EAGLE MOUNTAIN PLANNING COMMISSION MEETING

September 24, 2019, 5:30 PM

TITLE:	John Walden Clubhouse - Site Plan & Conditional Use - Public Hearing
ITEM TYPE:	Conditional Use Permit and Site Plan
APPLICANT:	Evans & Associates Architecture (Chad Spencer)

ARCHITECTURAL SITE PLAN

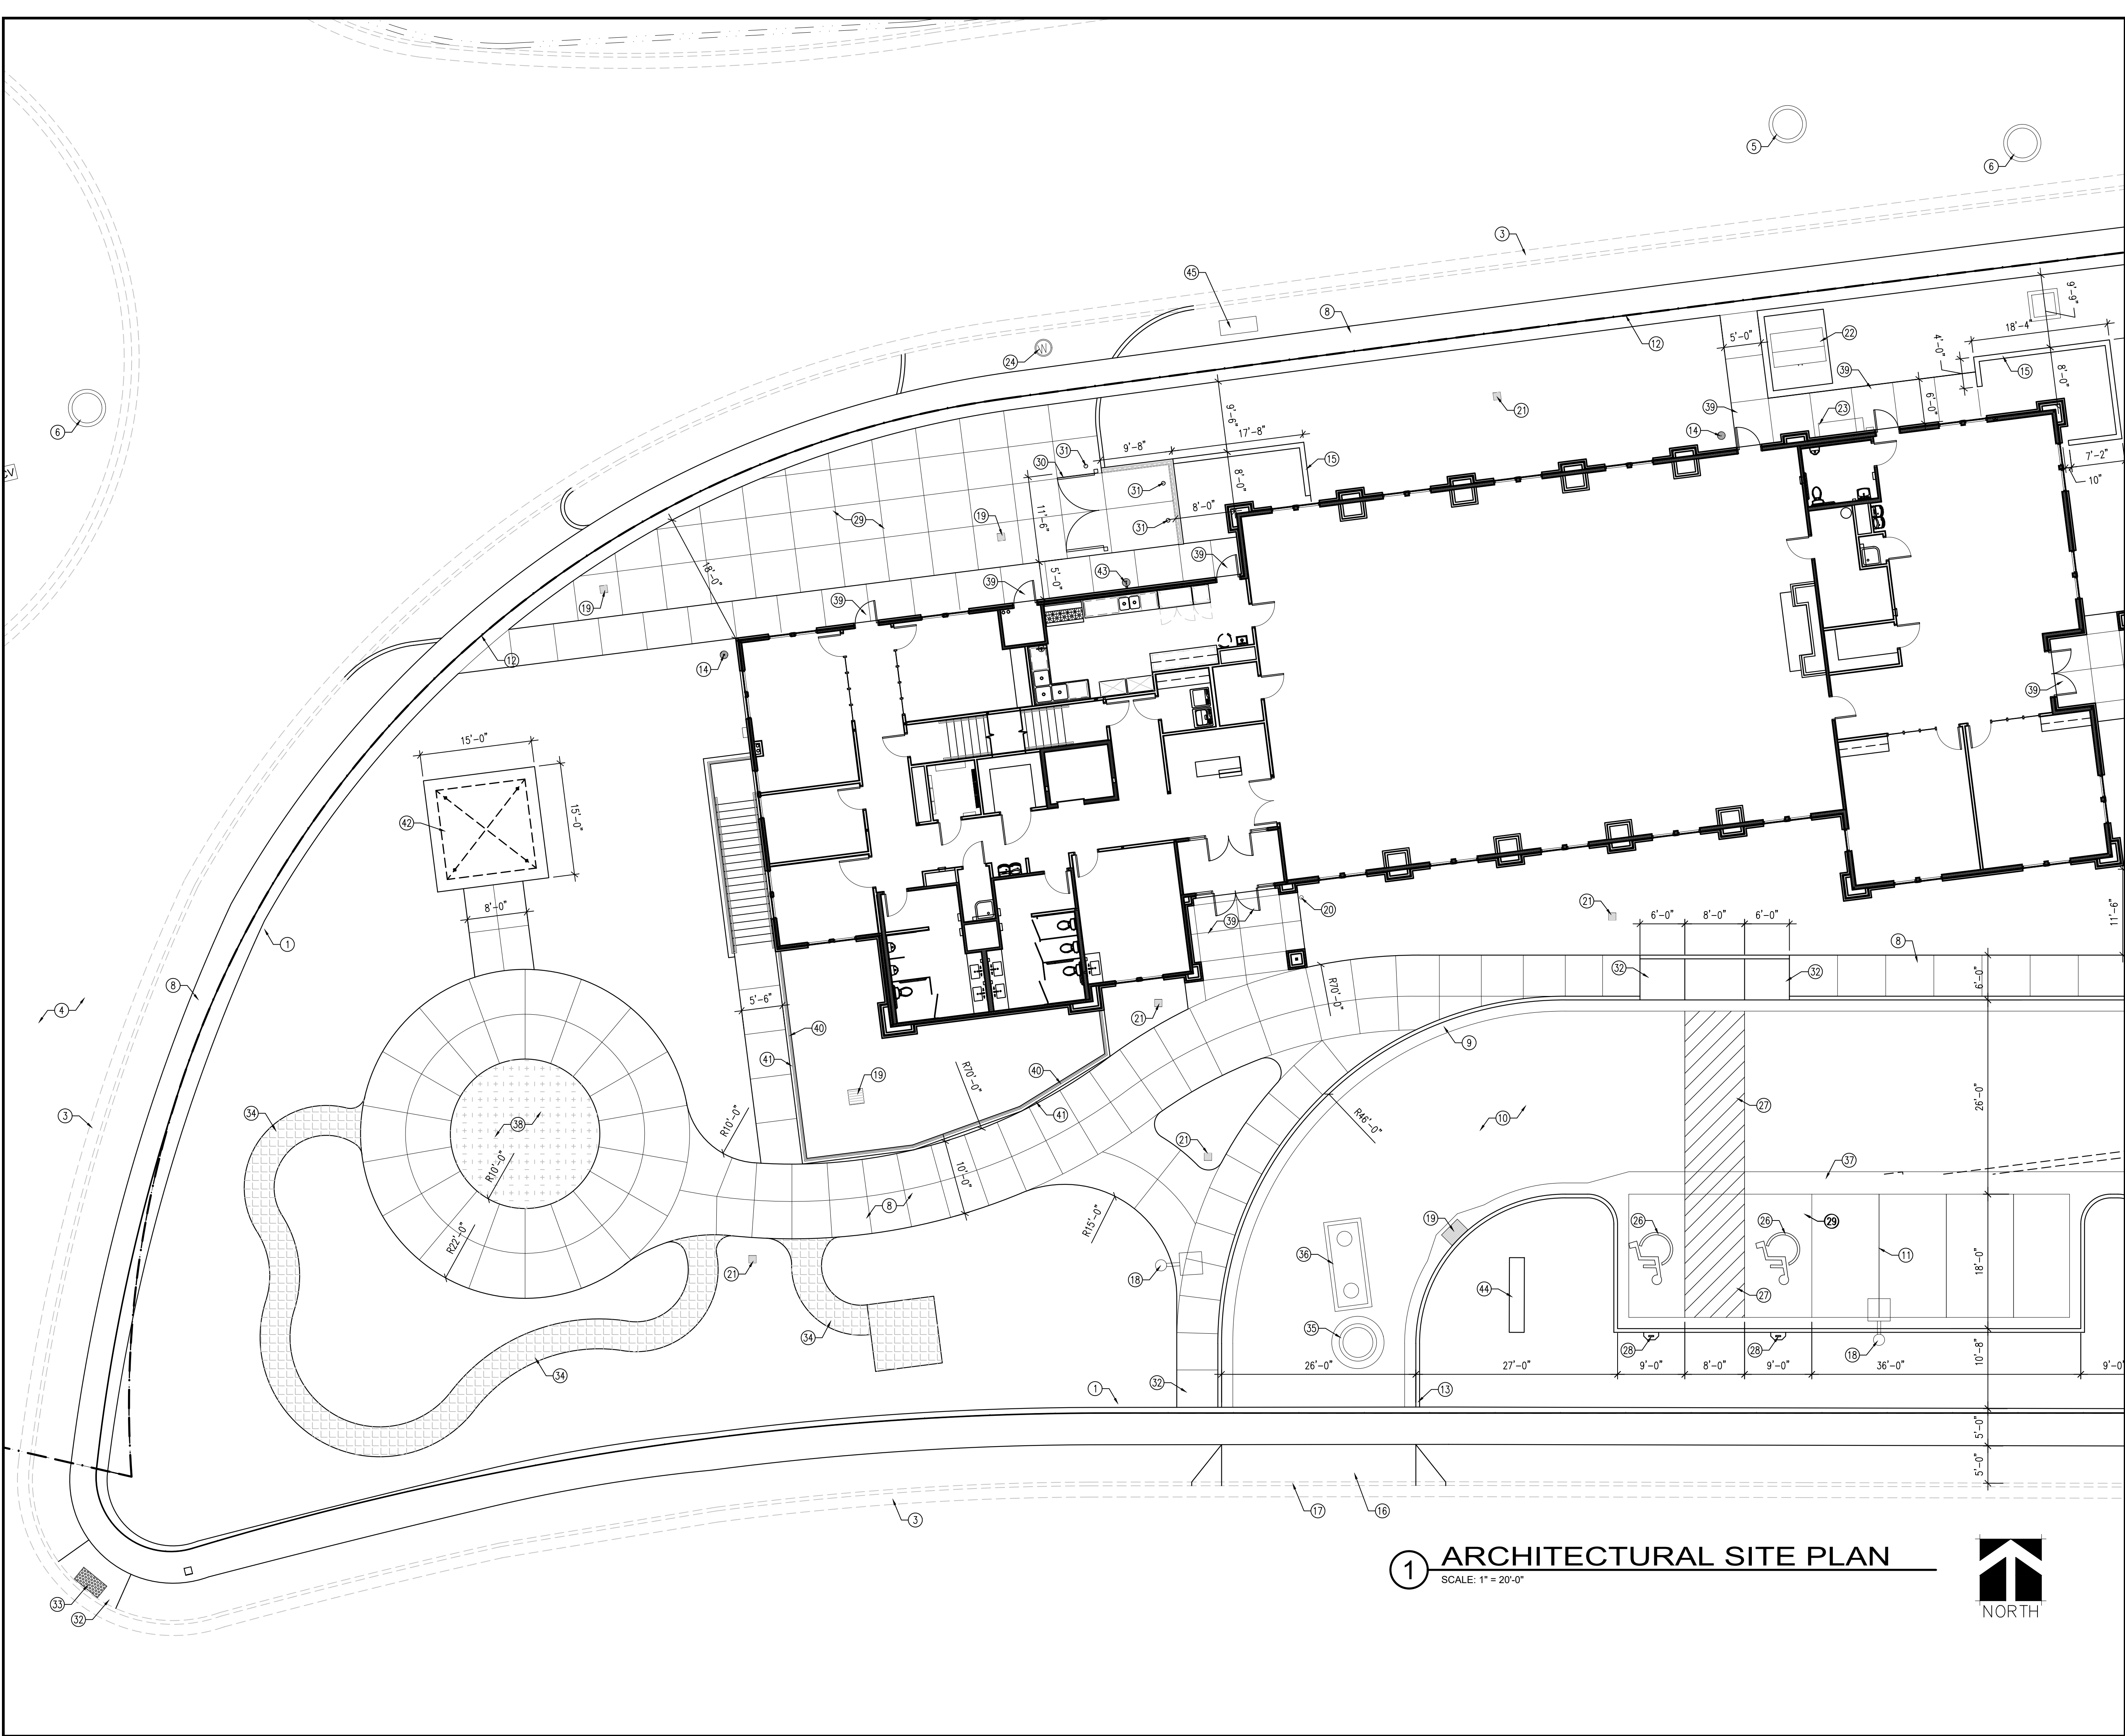
A breakdown of the required and provided parking is located on the site plan. The requirement for reception use, however, should be listed as 1 stall per 250 sq ft of gross floor area. The project requires 45 parking stalls (Preschool - 5; Office - 18; Health/Fitness - 7; Reception - 15) and is providing 45. The project includes a drive-thru access for garbage disposal and materials/kitchen deliveries on the northwest corner at the roundabout. While this access is not ideal for traffic safety, the City Engineer has worked with the applicant to reduce it to a one-way drive-thru access and is comfortable with the proposal.
